TECHNICAL SERVICE BULLETIN

REF.: ENGINE
NO.: EN91-002
DATE: FEBRUARY 15, 1991
MODEL: SV, ST, SW

VALVE STEM OIL SEAL MODIFICATION FOR 3S-FE AND 5S-FE ENGINES

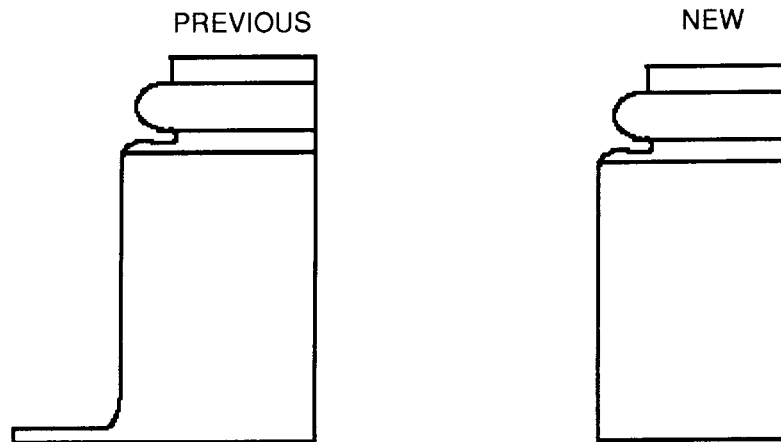
To improve oil sealing, the design of the intake valve stem oil seal has been changed.

PREVIOUS P/N

90913-02062

NEW P/N

90913-02090

Seal, Valve Stem Oil
(for intake valve)

NOTE: Previous and new parts are interchangeable.
